# CONSTRUCTION PLANS FOR HILLSIDE AT LORSON RANCH FILING NO. 1 STREET & STORM SEWER CONSTRUCTION PLANS

**HILLSIDE AT LORSON RANCH FILING NO. 1  
STREET & STORM SEWER  
CONSTRUCTION PLANS**

DATE:  
DEC 1, 2022  
PROJECT NO.  
100.065  
SHEET NUMBER  
**C1.1**  
TOTAL SHEETS: 47

SHEET NUMBER  
C6.21

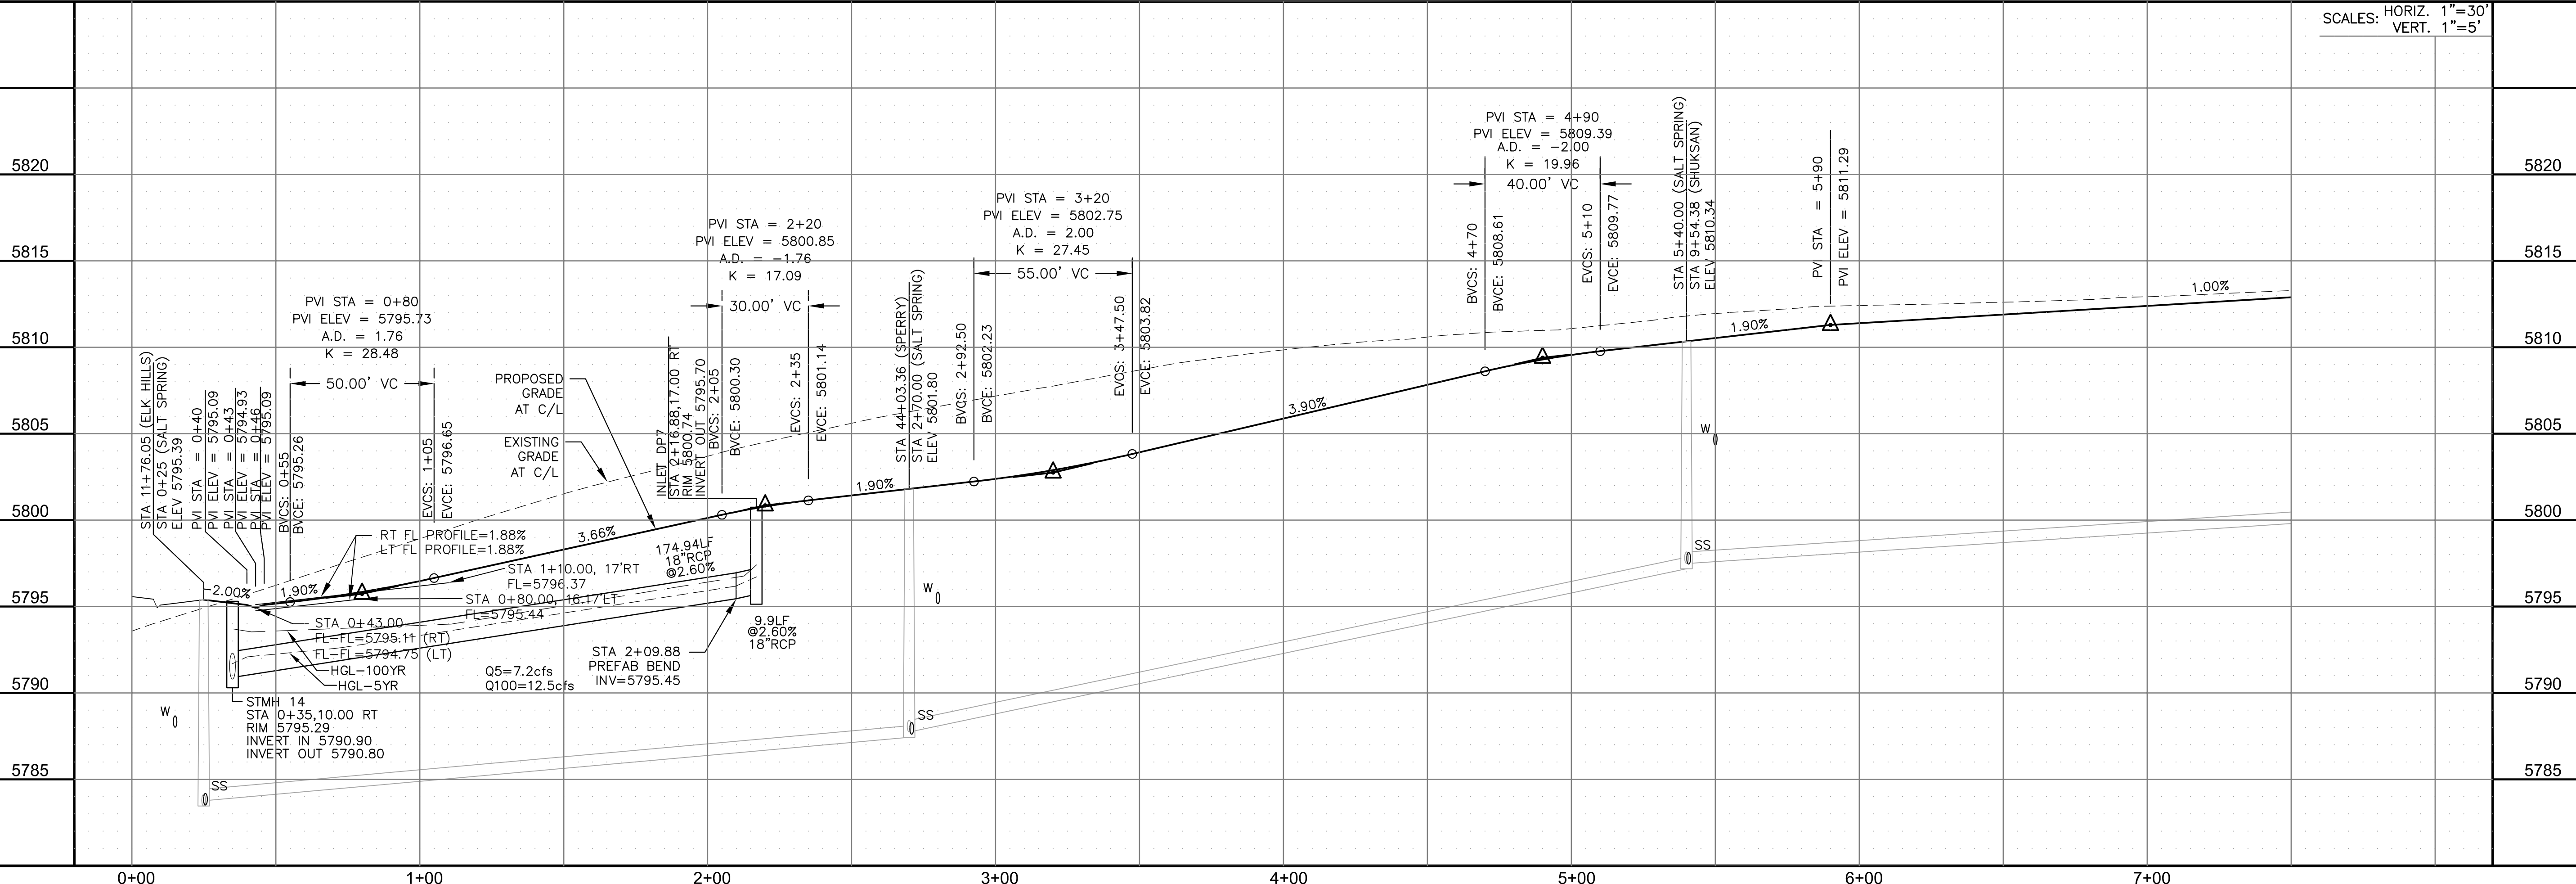
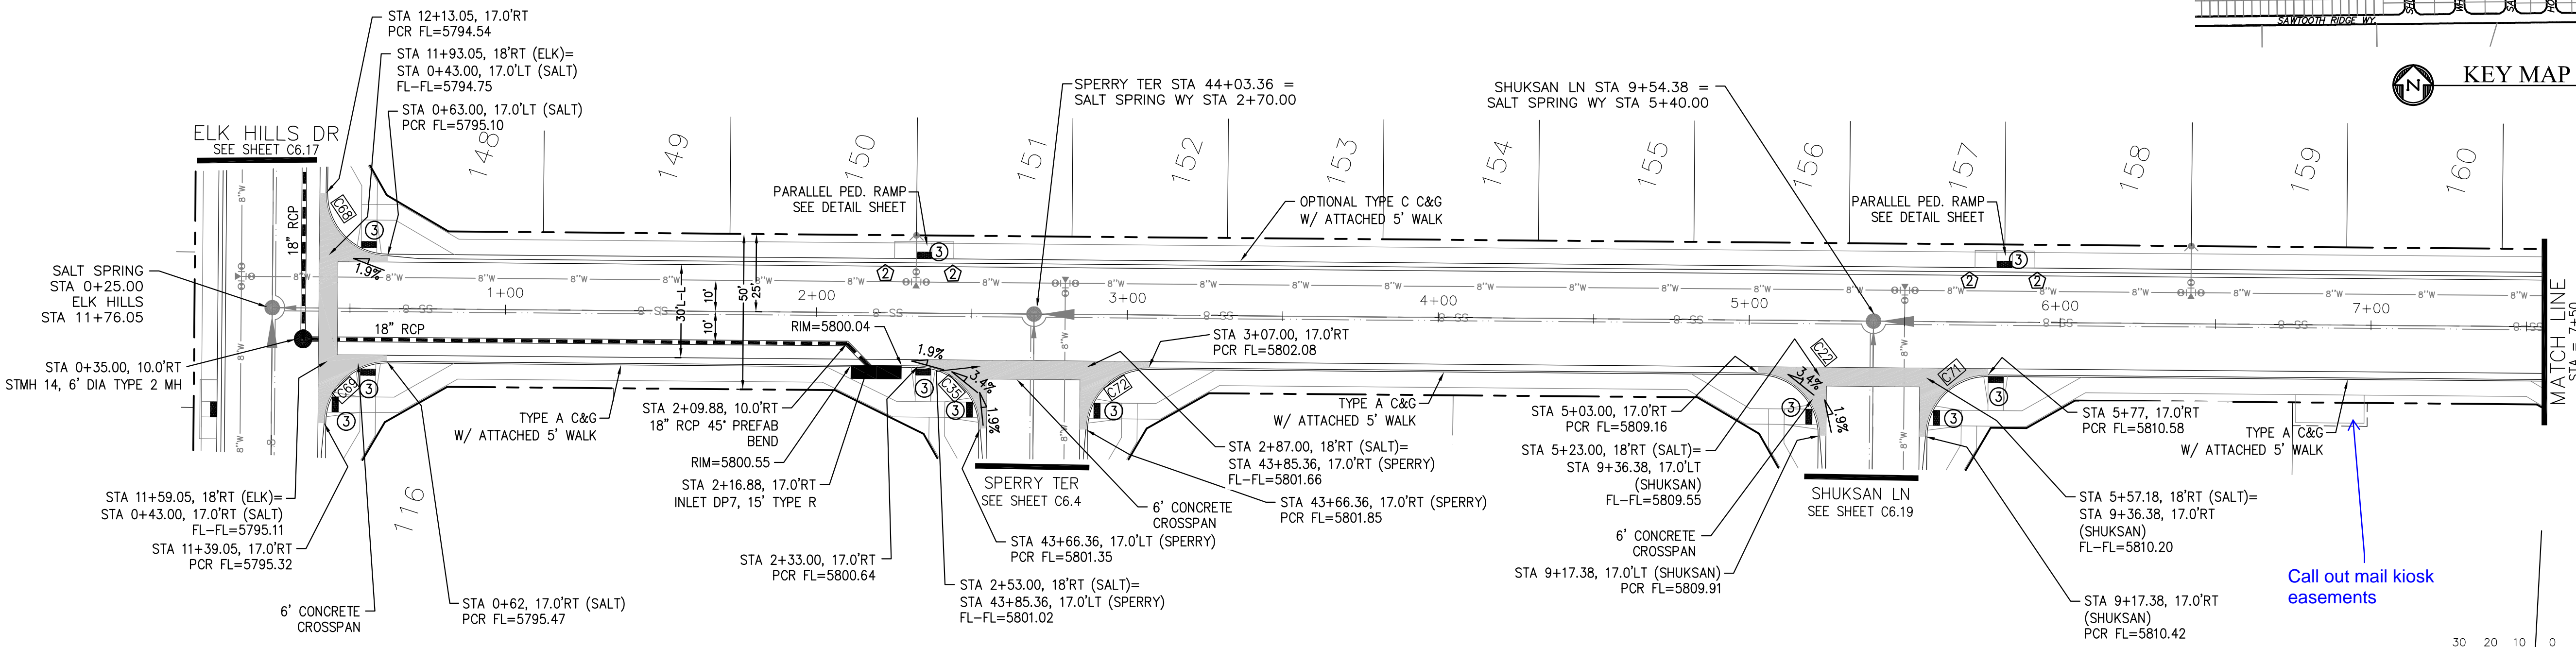
Call out mail kiosk easements
